STAFF REPORT

COLERAIN ZA1998-01

DISCOUNT TIRE

REQUEST: Major Modification to an approved Final Development plan in an existing “PD-B” Planned Development Business District

PROPOSED SITE PLAN

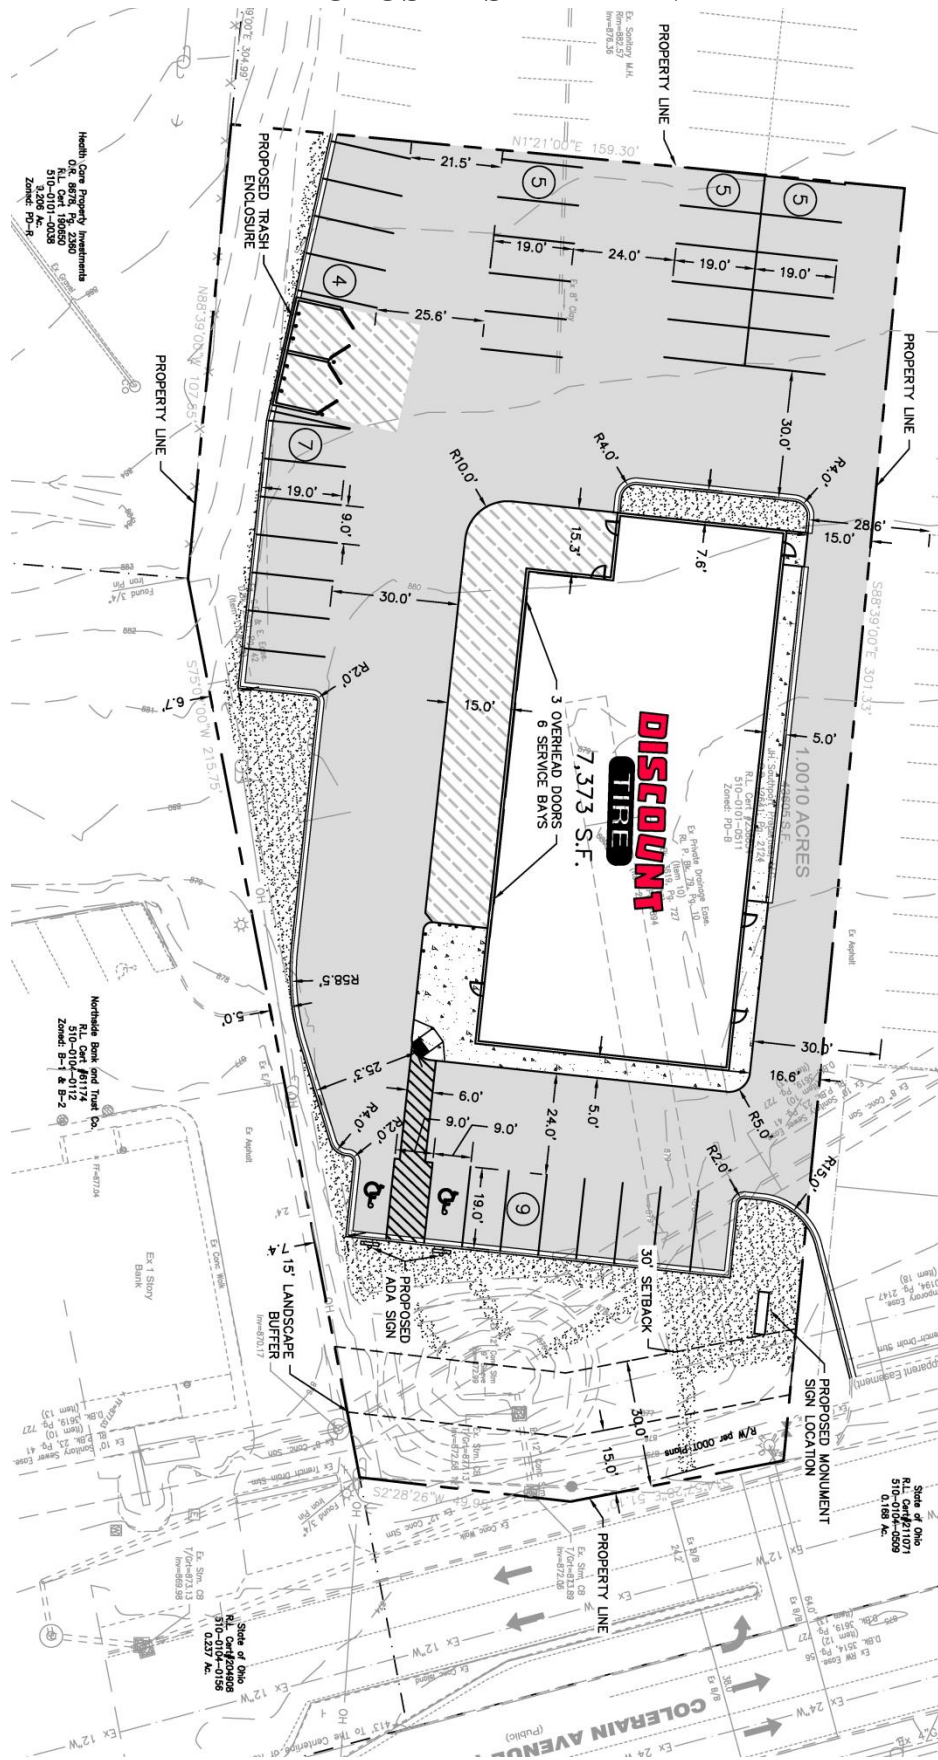
- *Therefore, staff finds that a future vehicular access easement should be provided to the southern property line to allow future connection to the property to the south.*

***Findings:** The submitted site plan does not show any walkway connection to the public sidewalk along Colerain Avenue from the building. Staff recommends that a walkway be installed from the building entrance to the existing public sidewalks along Colerain Avenue.*

5. That a lighting plan in compliance with the Zoning Resolution and with Variance #1 below shall be submitted as part of the Final Development Plan.
6. That the building shall meet the design standards of Article 12.11 of the Zoning Resolution
7. That a pedestrian walkway shall be installed from the front of the building to the existing public sidewalk along Colerain Avenue.
8. That a 30-foot access easement for future vehicular use shall be identified to the southern property line to permit the adjacent property to connect through the subject site to be effective if/when this adjacent property is redeveloped.

SITE LIGHTING PLAN

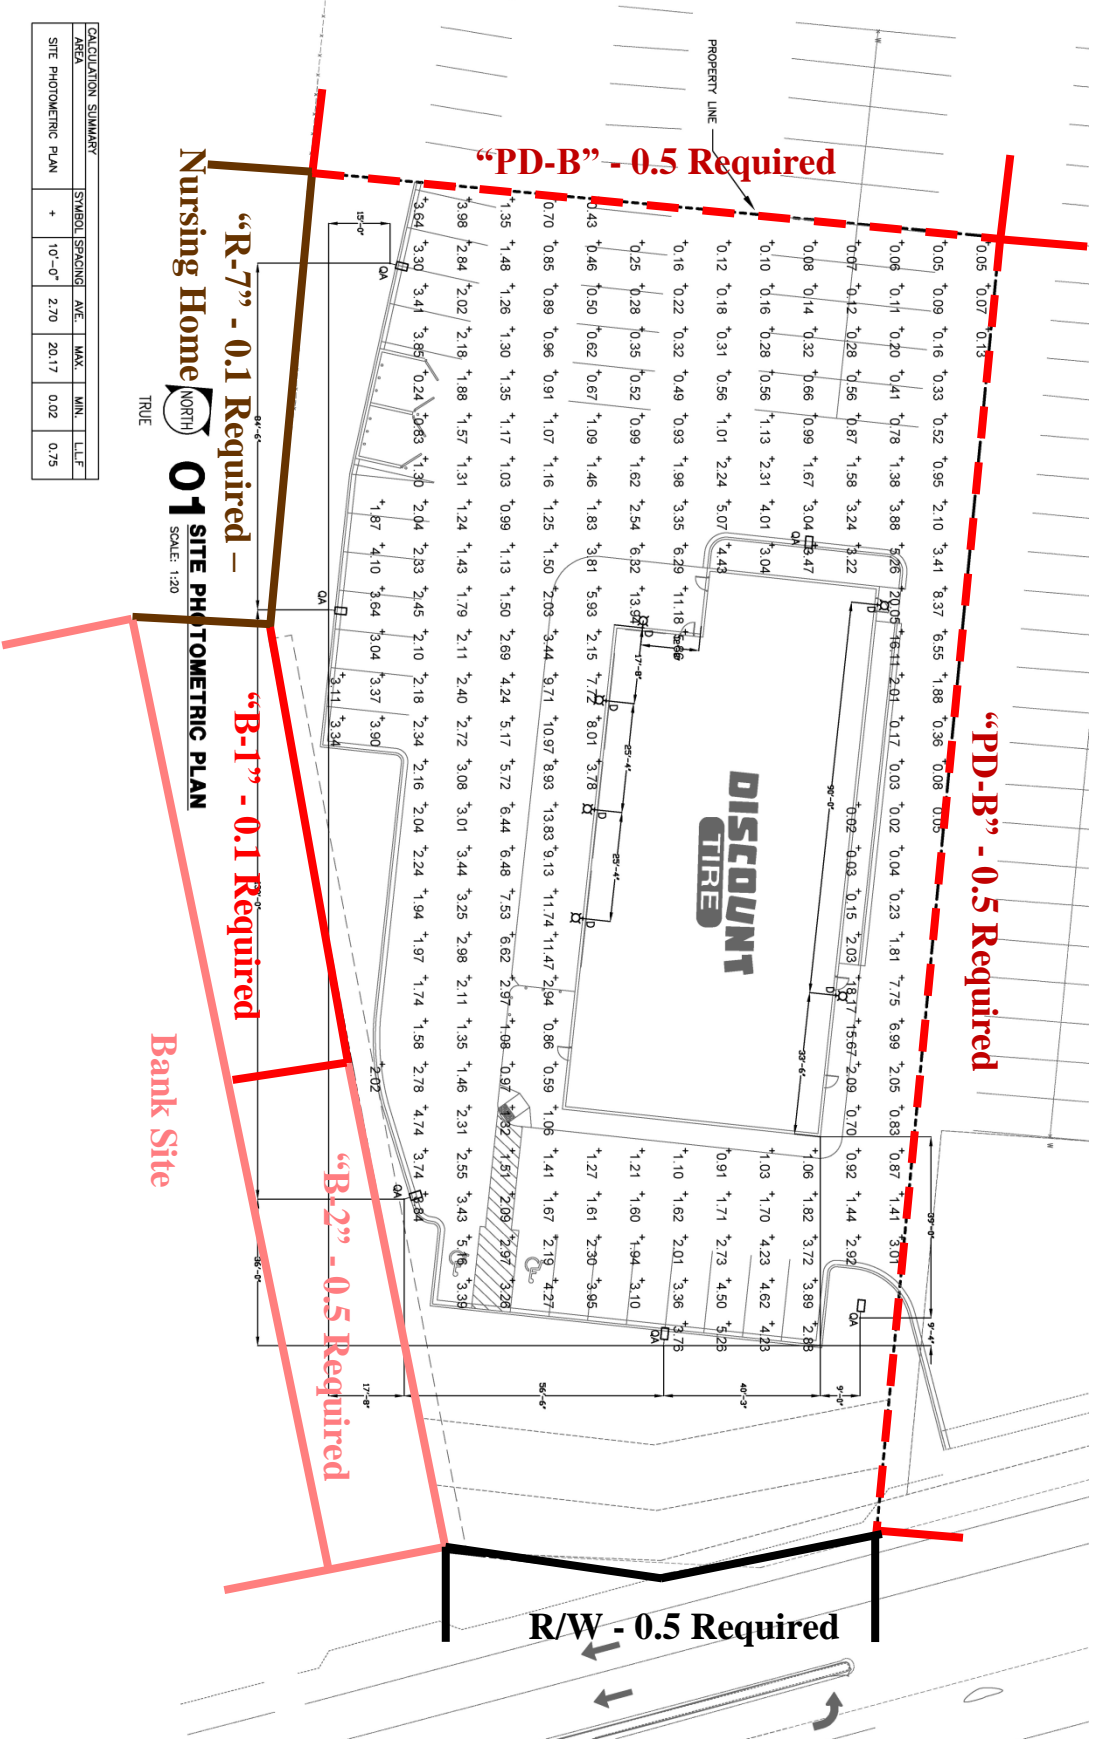
The article states that cutoff lights may not be more than 24 feet. The table, then, states that the maximum average illumination over parking lots is 2.0 footcandles and a maximum illumination of 0.5 footcandles at property lines except for portions adjacent to “R-7” or “B-1” zoning districts, where 0.1 footcandles is the maximum illumination permitted.

Findings: Staff finds several compliance issues with the lighting standards. The submitted site photometric plan does not show proposed pole fixture heights; therefore, conformance with this portion of the article cannot be determined. The calculated average for the lot is 2.70 footcandles, 0.70 above the maximum 2.0 footcandles. The submitted site photometric plan does not show illumination levels at the property lines, but it appears that the development would be above maximum illumination levels at some points along all property lines, as shown on the attached lighting plan. Staff recommends a variance on the north and west property lines because they are internal to the overall Planned Business Development. For all other areas, however, staff recommends that the development should meet the standards of the zoning resolution.

1. Table 12-11 – That illumination levels be permitted to exceed 0.5 footcandles along the northern and western property lines internal to the commercial development.
2. Table 14-1 – That a minimum 20-foot wide buffer yard shall be permitted adjacent to the PD-R multifamily site to the south where a 40-foot buffer yard is required and that a 10-foot wide buffer shall be permitted adjacent to the B-1 portion of the site to the south where a 30-foot buffer is required, provided that all buffer areas include landscape materials consistent with the Zoning Resolution.

SITE LANDSCAPE PLAN

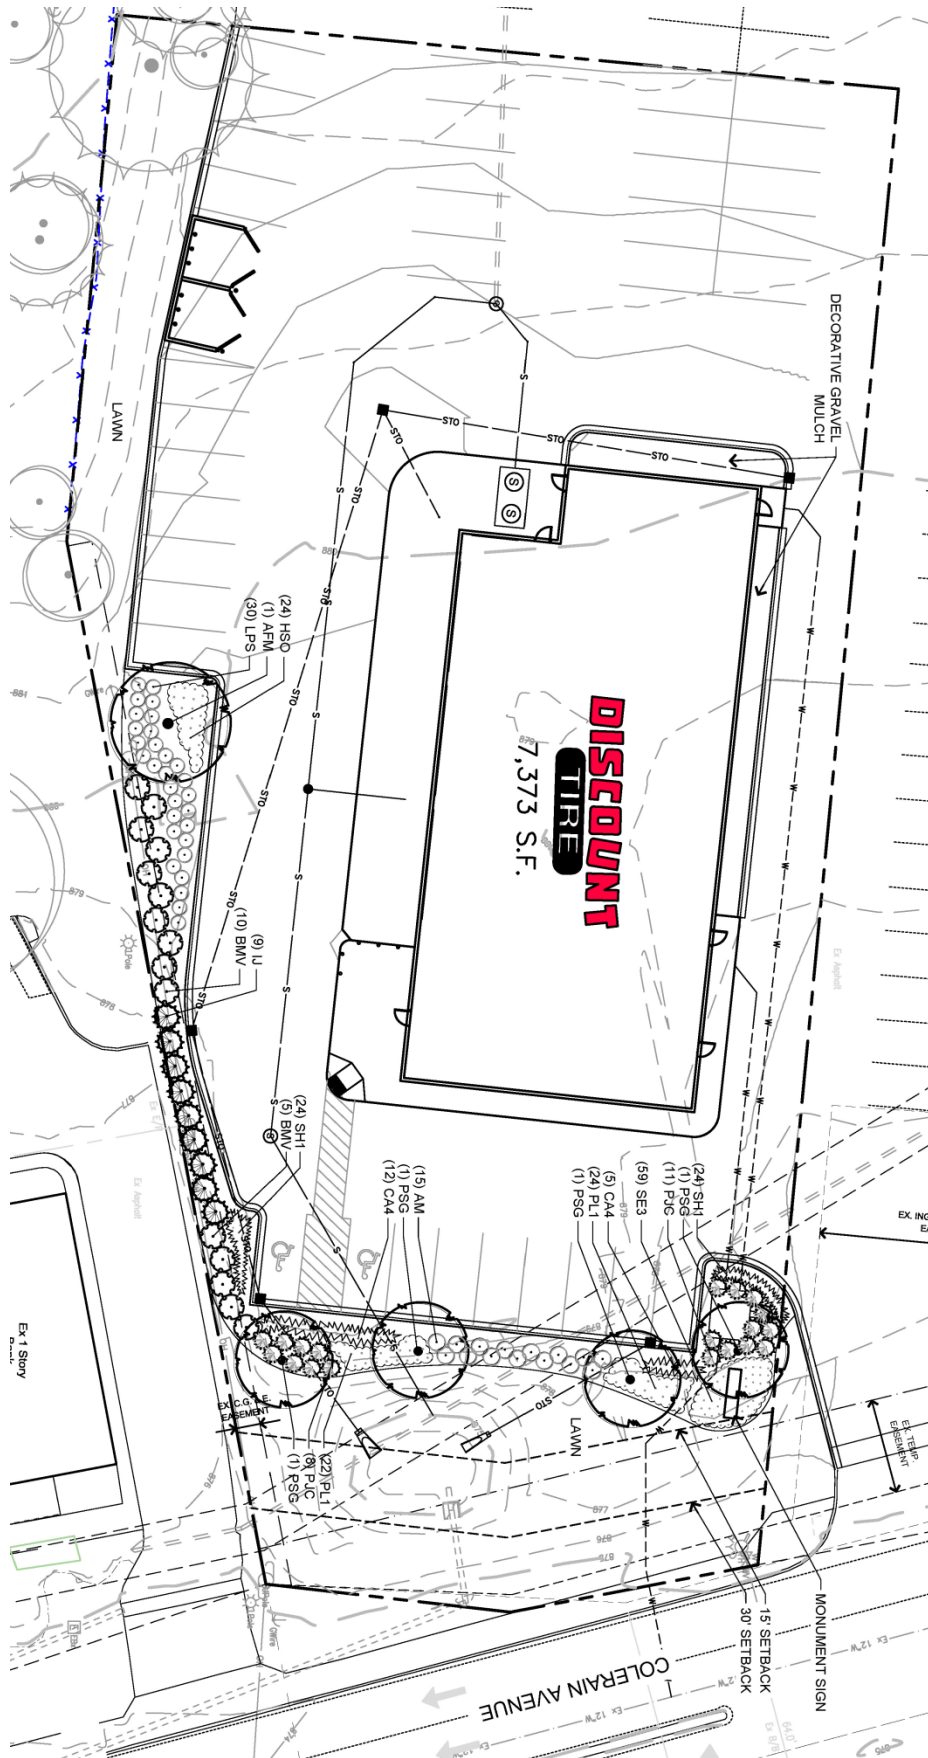
***Findings:** The southern property line borders all three of these zone types from west to east, and the proposed site plan does not include the required buffer yard widths. Staff recommends a variance to the 40-foot buffer requirement on the western portion of the southern property line where the lot abuts the nursing home, a “PD-R” district, being viewed as “R-7” – Multifamily Residential. The nursing home building is setback far enough away to not necessitate a 40-foot buffer yard. The other abutting use is a bank that is zoned both “B-1” and “B-2” but, as per the opinion of the staff, should be viewed entirely as “B-2”. The existing development on the lot in question has a 20-foot buffer adjacent to the nursing home and a 10-foot buffer adjacent to the bank. As such, staff recommends that these buffers remain in place at their current widths. Staff also recommends the required landscaping be planted per code; the lot has 325 lineal feet of lot line requiring a buffer, which comes to a total of 16 evergreen trees and 33 shrubs as well as a 6-foot high fence, wall, or earth mound/berm.*

***Findings:** The submitted landscape plan does not propose any landscaping within the parking lot where 900 square feet of interior parking lot landscaping is required. The proposed development requires 34 parking spaces and is proposing 35, so the parking lot can have one less parking space dedicated to landscaping. Also, other areas exist off the eastern end of the rear two parking rows where landscape islands could be added. A shared parking agreement between the site in question and the adjacent commercial uses to the west and north was cited in the 2011 case and shared parking could be used in this instance to allow for further reduction of parking spaces in favor of the required interior parking lot landscaping. The applicant could also reconfigure the internal building uses in order to necessitate less parking in order to create additional space for landscaping. Staff recommends that conformance to this article remain a requirement.*

1. That all conditions approved as part of case Colerain ZA1998-01 shall remain in effect for the Zone Amendment area.
2. That the Final Development Plan shall comply with all requirements of the Ohio Department of Transportation.
3. That a landscape plan in compliance with Article 14 of the Zoning Resolution and with Variance #2 below shall be submitted as part of the Final Development Plan.
4. That freestanding and building signage shall comply with the requirements of

CONCEPTUAL 1ST FLOOR PLAN

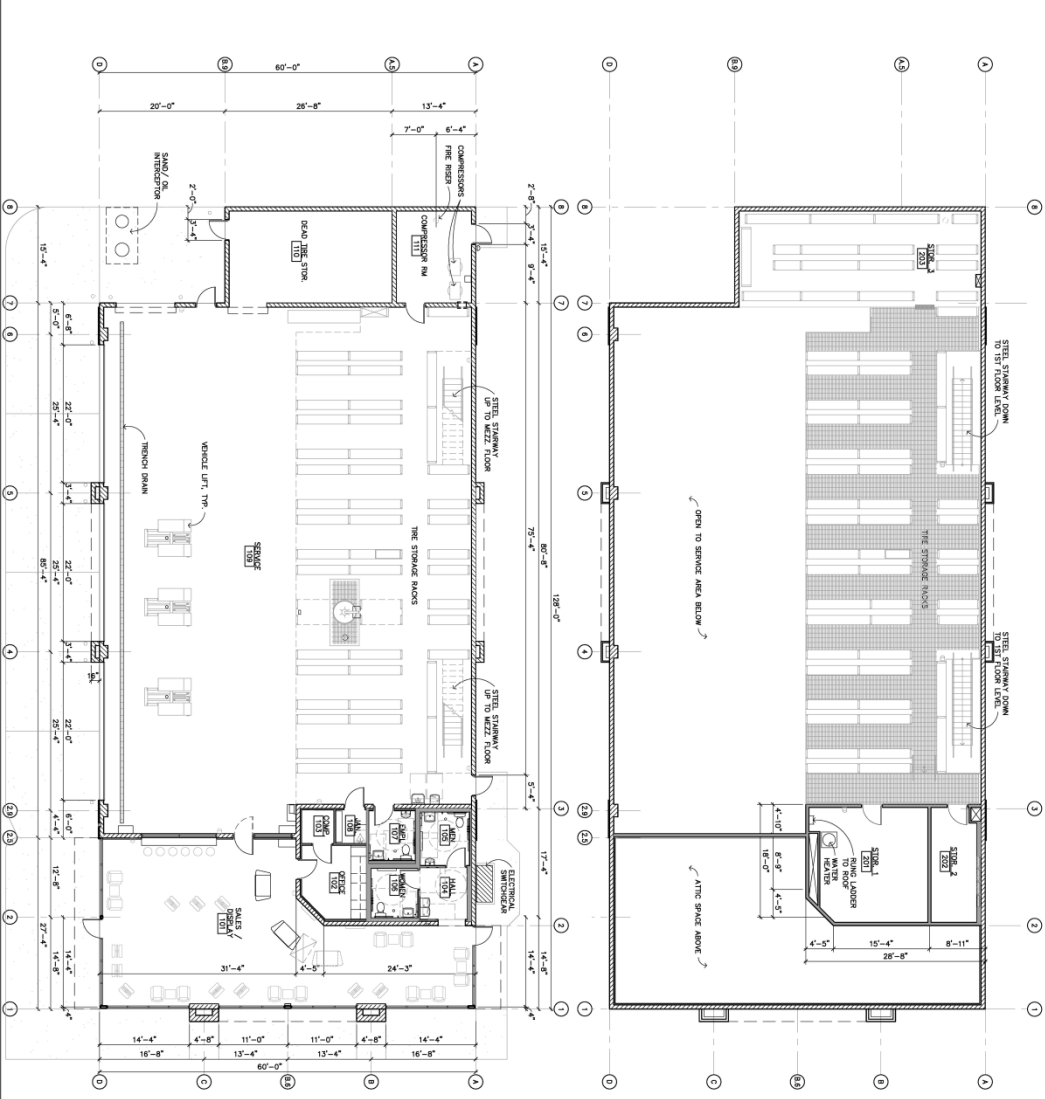
Findings: The submitted conceptual floor plans contain two customer entrances on the north and south sides of the building close to the east end of the building. However, no customer entrances are directly located on the east side, which faces Colerain Avenue. Staff recommends that the building be designed to comply with the architectural standards of the zoning resolution unless waived or modified by the
